# Access Compliance Report

## Public Rights-of-Way

### (Curb Ramps)

Intersection ID: 14086	Main Street: BALDWIN_AV	Cross Street: E_3RD_ST	Location: E
ADA ID: B02BB0EAF15B	Ramp Type: Perp	Initial Pass/Fail: Fail	Overall Compliance: No
Severity Score: 21.25			
Codes/Mitigation Info/Possible Solution		Field Measurements/Component Compliance

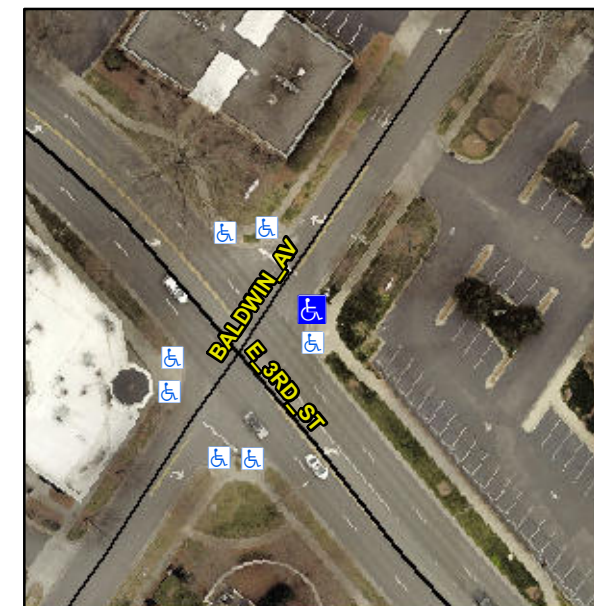
**Not Found, R304.5.1, R304.5.3**

Compliance	Description	Data	Compliance	Description	Data
N/A	Ramp Length (in)	93.0	Yes	Ramp Slope (%)	6.9
No	Ramp Width (in)	36.0	No	Ramp XSlope (%)	5.1
N/A	Flare Type LT	N/A	N/A	Flare Type RT	N/A
N/A	Flare Slope LT (%)	N/A	N/A	Flare Slope RT (%)	N/A
N/A	Flare Traversable LT?	N/A	N/A	Flare Traversable RT?	N/A
N/A	Landing Length (in)	N/A	N/A	DWS Provided?	N/A
N/A	Landing Width (in)	N/A	N/A	DWS Contrast?	N/A
N/A	Landing Slope (%)	N/A	N/A	DWS Length (in)	N/A
N/A	Landing X Slope (%)	N/A	N/A	DWS Full Width?	N/A
N/A	Landing Curb? (Y/N)	N/A	N/A	DWS Offset (in)	N/A
N/A	Shared Landing?	N/A			
N/A	Gutter Ponding?	N/A	N/A	Gutter Slope (%)	N/A
N/A	Gutter Lip Ht (in)	N/A	N/A	Gutter X Slope (%)	N/A
N/A	Painted X Walk1?	No	N/A	Painted X Walk2?	N/A
	X Walk 1 Direction	To NW		X Walk 2 Direction	N/A
N/A	X Walk 1 Width (in)	N/A	N/A	X Walk 2 Width (in)	N/A
	X Walk 1 Slope (%)	2.6		X Walk 2 Slope (%)	N/A
	X Walk 1 X Slope (%)	2.9		X Walk 2 X Slope (%)	N/A

**Remove & Replace Entire Ramp.**
